### Nanuet UFSD –Phase 3 Projects

MECHANICAL ROOM HIGH SCHOOL BOILER ROOM COORDINATED SHOP DWG

**SAGE LOG NO. M-33**

ARCH	KSQ Design		
ENG	Sage Engineering Associates		
PROJECT	Nanuet High School 103 Church St. Nanuet, NY 10954		
TITLE	BASEMENT MECHANICAL ROOM		
GRP LDR	MC	PRO MGT	J23-287
DATE	11/09/2023	SCALE As Indicated	J23-287 MP-BM-MER 0

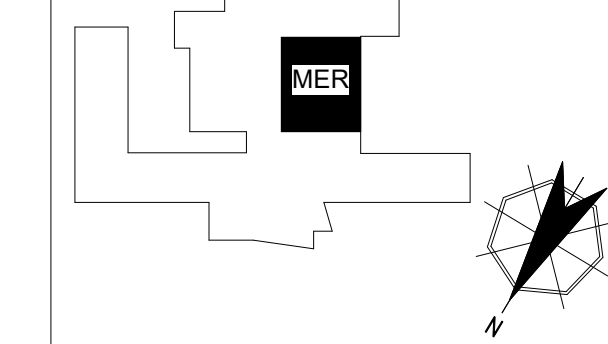
- 1. At the steam main tap, if elevation space allows, provide steam tap at 45 degree angle up to
- avoid the flow of condensate into the branch steam line, then 45 back down to the 11'-2-1/8" CL
- elevation.

- 1 RELOCATE EXISTING SMALL DIAMETER PIPE IN CONFLICT WITH NEW STEAM
- 2 NO PIPING TO BYPASS FILTER FEEDER SHOWN ON CONTRACT DOCUMENTS
